**Re: Draft Environmental Impact Report for the Market and Octavia
Neighborhood Plan**

Re: 2003.0347E- Market and Octavia Neighborhood Plan

Figure 4-14
Revised
Viewpoint S1: Market Street, Looking East

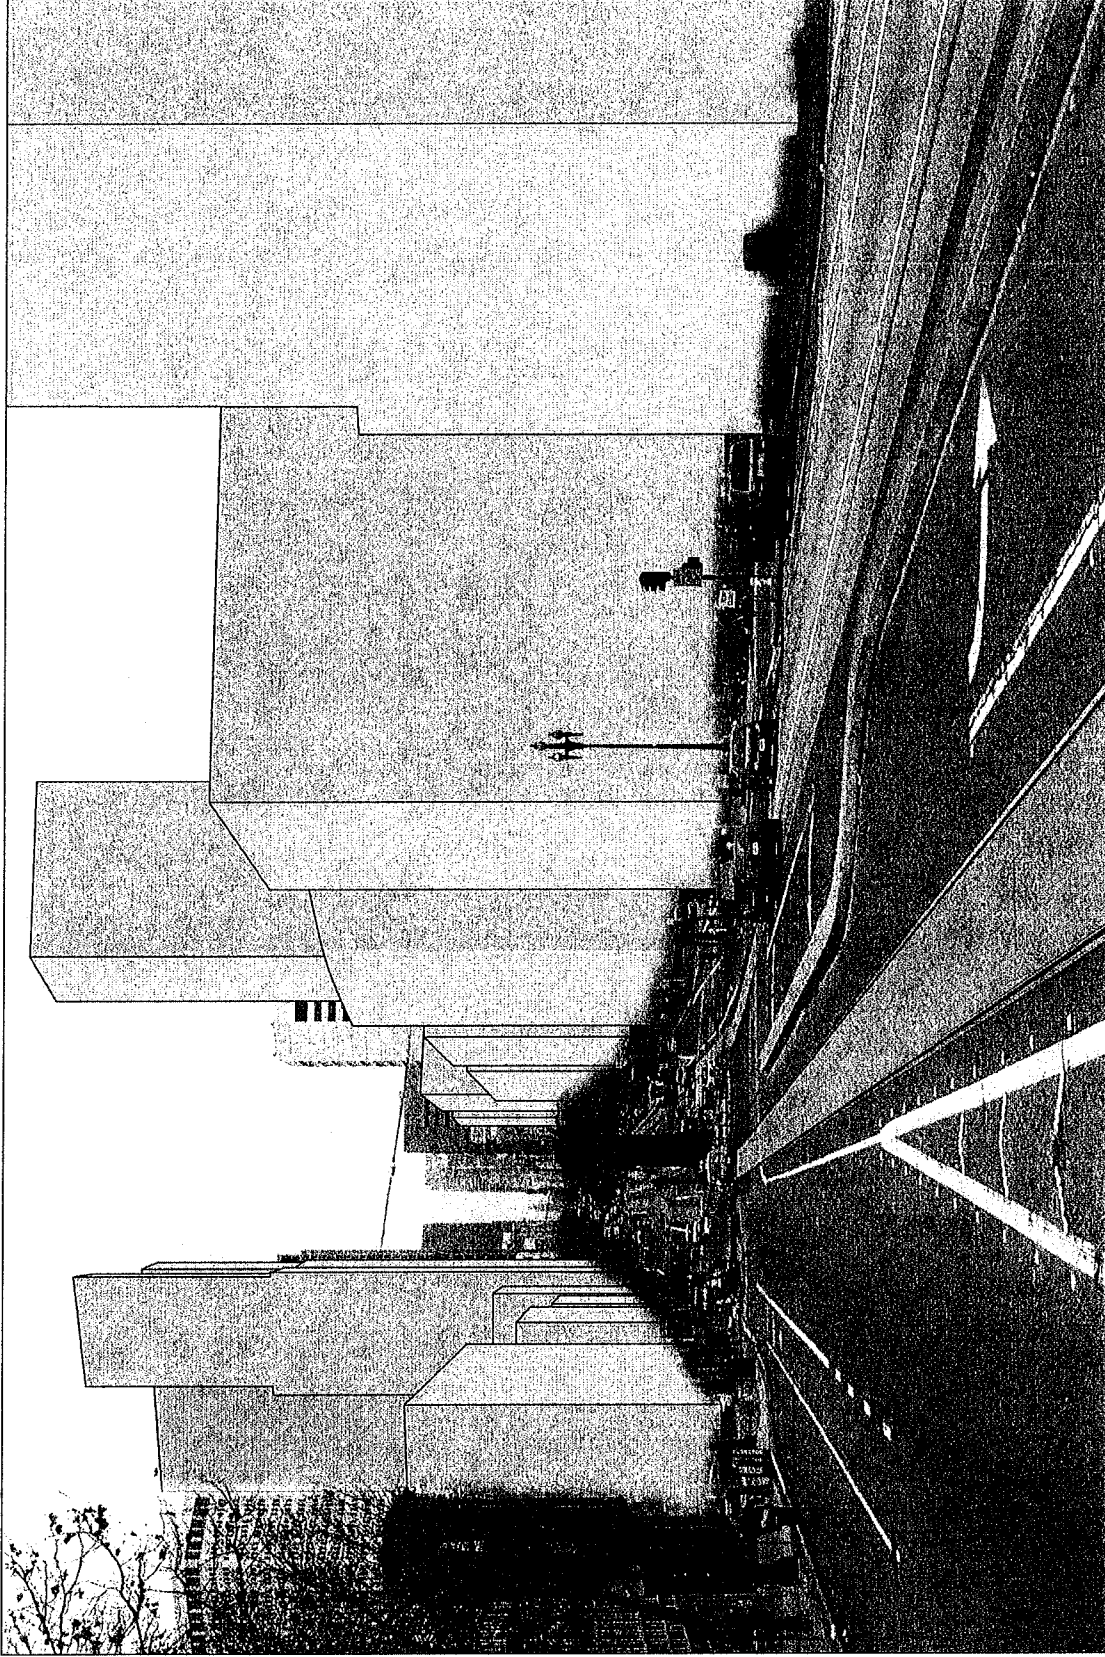
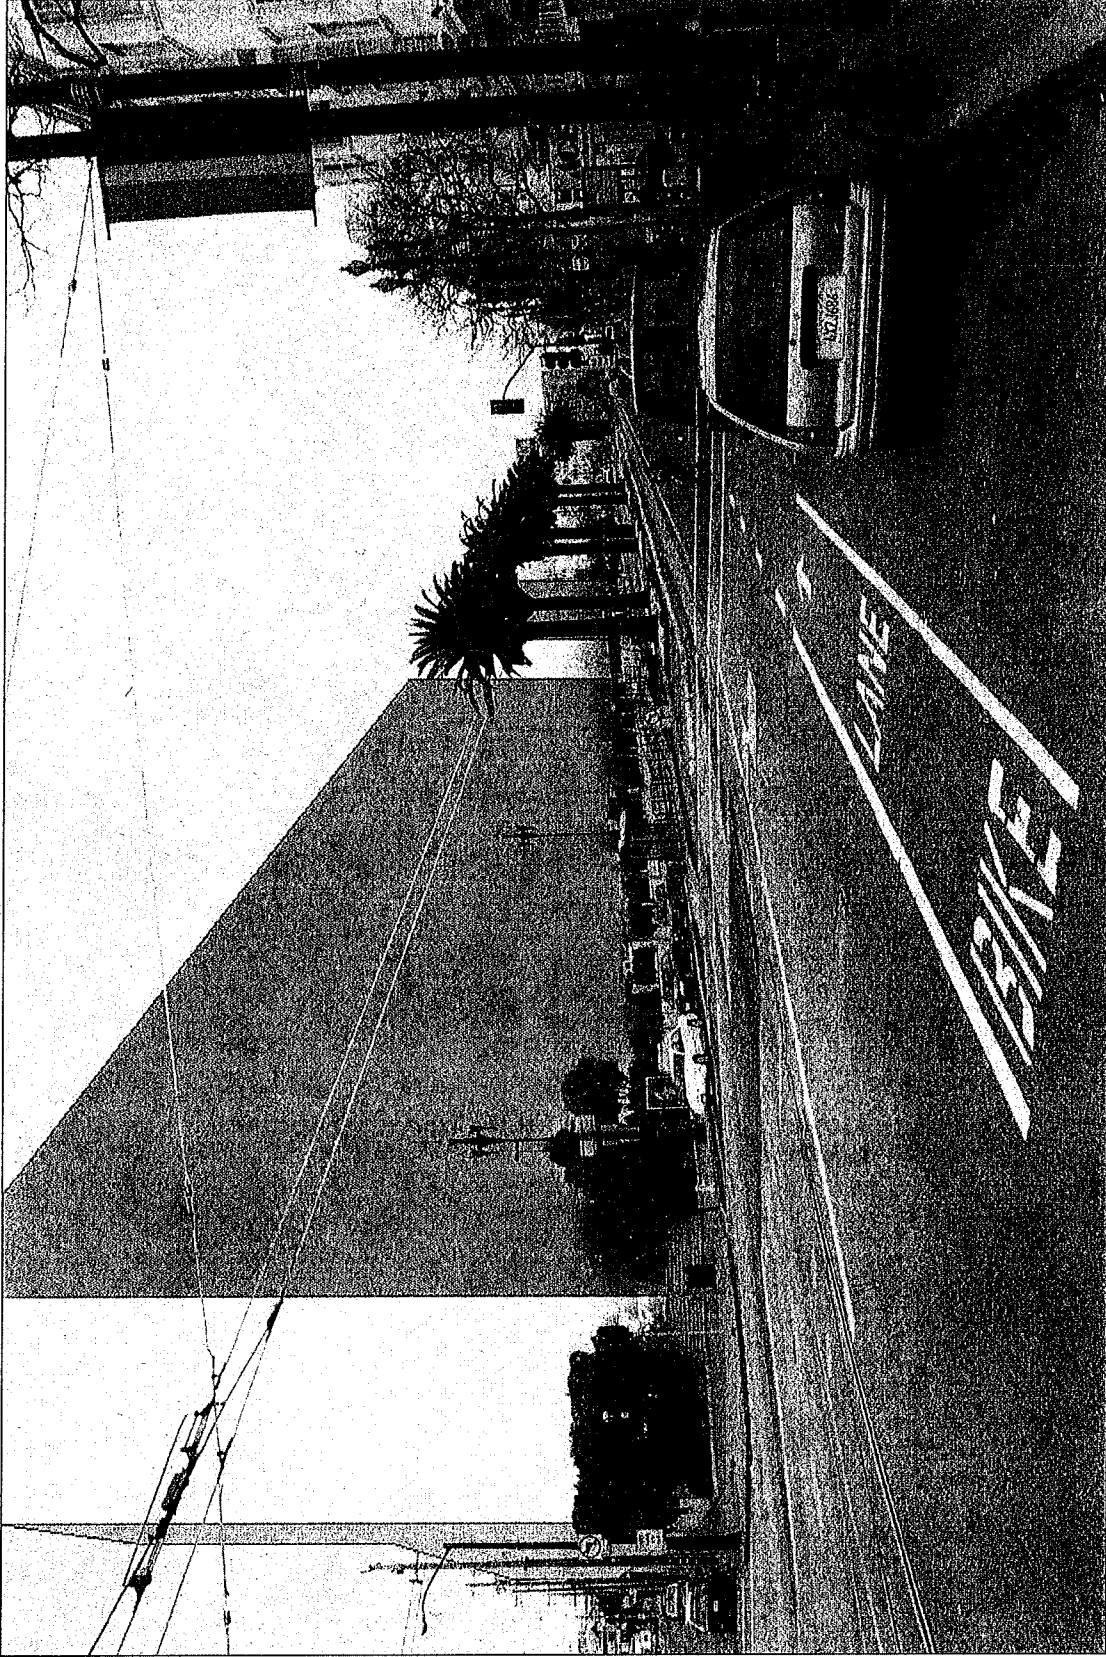
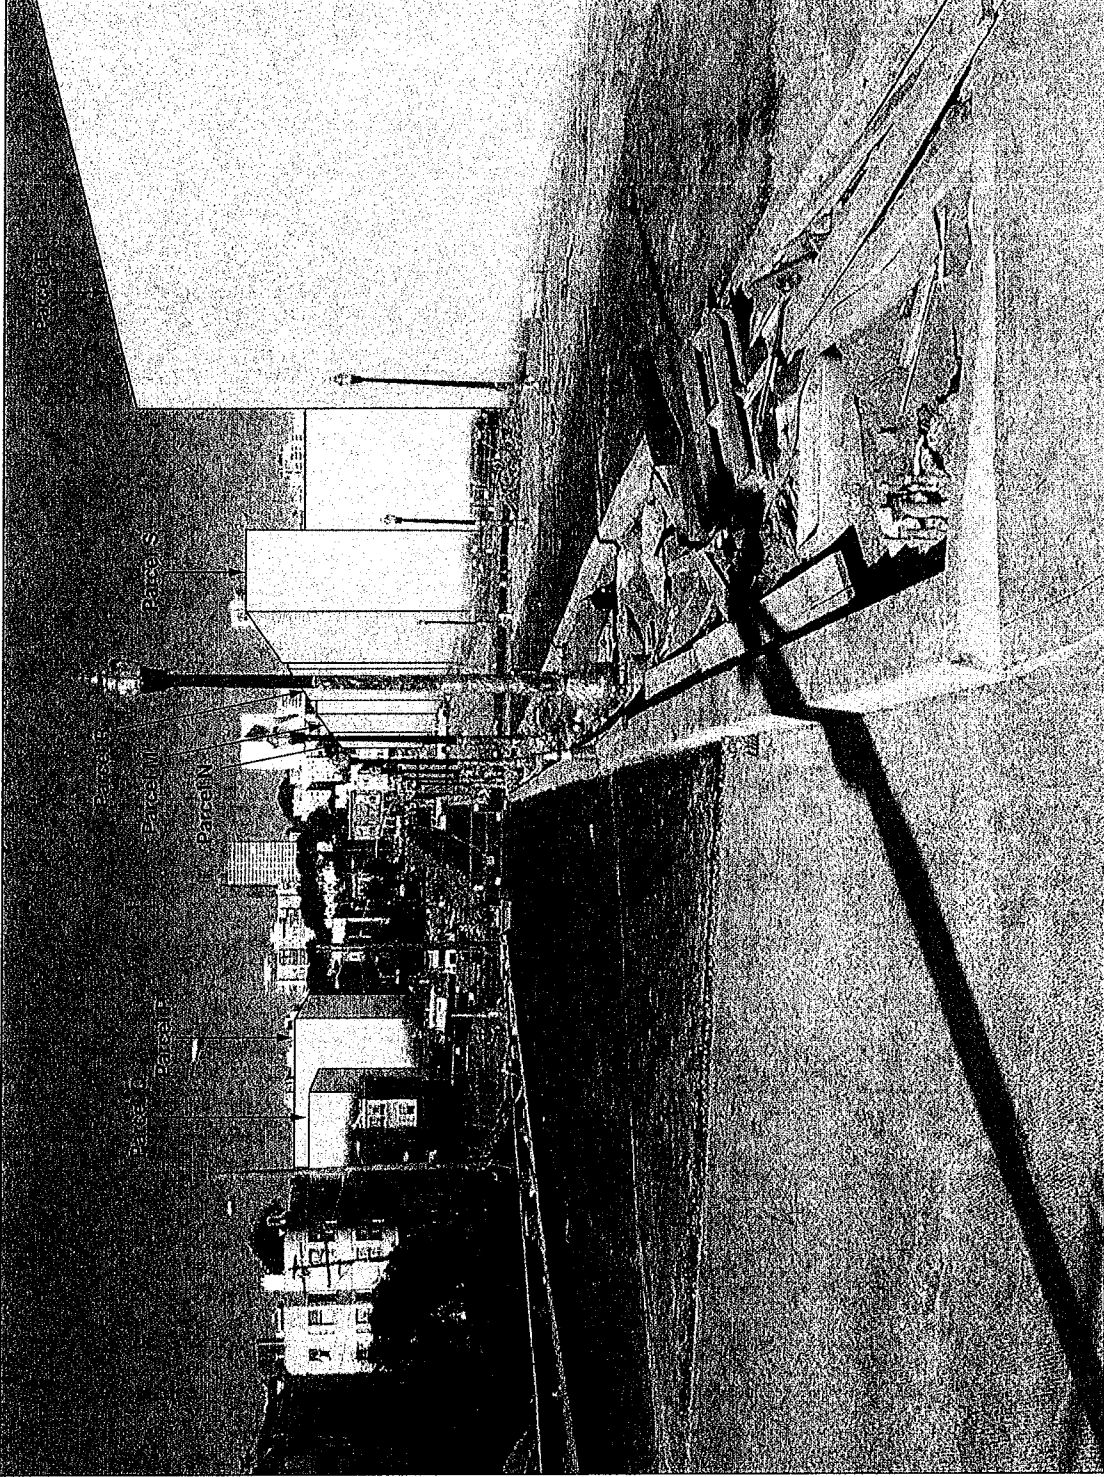
- Figure 4-14 on page 4-101 of the DEIR, Figure 4-15 on page 4-103 of the DEIR, and Figure 4-16 on page 4-109 of the DEIR are revised as shown on the following pages to include background fill. [AA-24]
- The text in Chapter 4, page 110 of the DEIR, first paragraph, second sentence is revised to read as follows:
